**AMENDMENTS TO THE DRAWINGS:**

## REMARKS

This communication is a full and timely response to the aforementioned non-final Office Action dated February 28, 2006. By this communication, claims 1 and 11, and Figs. 1 and 3J have been amended. Changes have been made to claim 1 to emphasize its original scope, and support for the claim can be found variously throughout the Specification, for example, at page 6, line 30 through page 7, line 14. Claim 11 has been changed for readability. Claims 1-23 are pending.

FIG. 3J

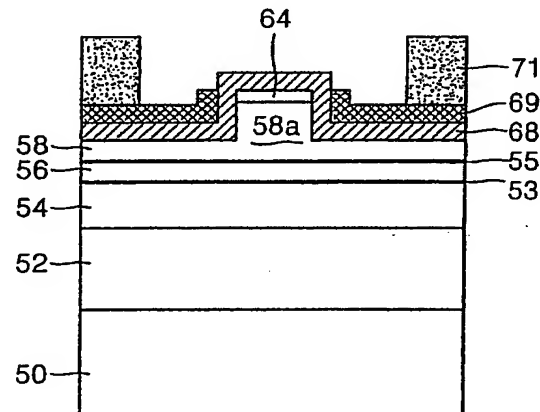
The attached drawing sheets include changes to Figs. 1 and 3J. These sheets replace the original sheets that includes Figs. 1 and 2 and Figs. 3I and 3J, respectively. In Replacement Sheet 1, Fig. 1 was amended to include a "Prior Art" legend. In Replacement Sheet 2, Fig. 3J was amended to change reference number "69a" to "69b".

Fig. 1 was objected to for failing to include a prior art legend. Fig. 1 has been amended to address the Examiner's concerns. In addition, Fig. 3J has been amended to change reference number "69a" to "69b". Applicants respectfully request that the objection to the drawings be withdrawn.
